ROBINSON LANDING

Alexandria, VA

BUILDINGS 01 & 02 SUPPLEMENTAL SUBMISSION MATERIALS

OCTOBER 05, 2015

REVISION COMPARISONS

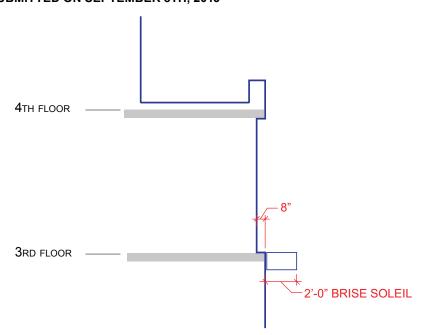
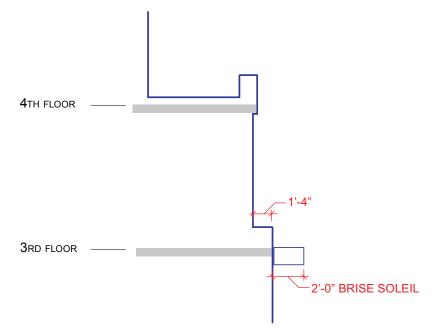
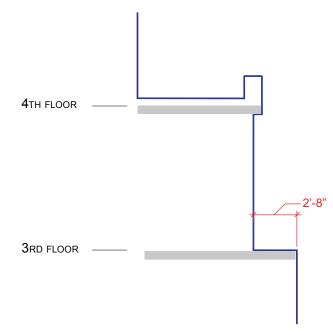
* CANOPIES SCREENING ROOFTOP MECHANICAL EQUIPEMENT WITH LOWERED HEIGHT AND REDUCED OVERHANG * INCREASED SETBACK AT 30 FOOT HEIGHT

Designed as a cap or "brow" to screen mechanical equipment as viewed from the waterside, the submitted design shows a height of 4'-6" above the main roof level. Upon review and discussion of the ground-level views with Staff, these elements have been lowered 1'-6" to 3'-0" above roof level and their horizontal projection has been reduced approximately 2'-0" to balance the proportional relationship.

BUILDING 02 OVERALL ELEVATIONS - REVISED

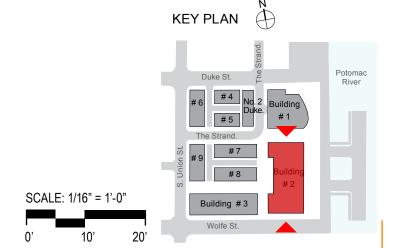
Articulation of 30' height datum at south façade of Building #2

The slate masonry at the fourth level of the horizontal bay projection has been set back approximately 1'-0" from the three floors below, and the depth at which the windows are inset at that level has been increased an additional 8". Also, a projecting stone cap has been incorporated at the sill line of those windows. Similarly with the vertical bay at the west side, a projecting metal cap has been added at the sill line of the fourth level windows, and the windows of the fourth and fifth levels have been set back approximately 1'-2".
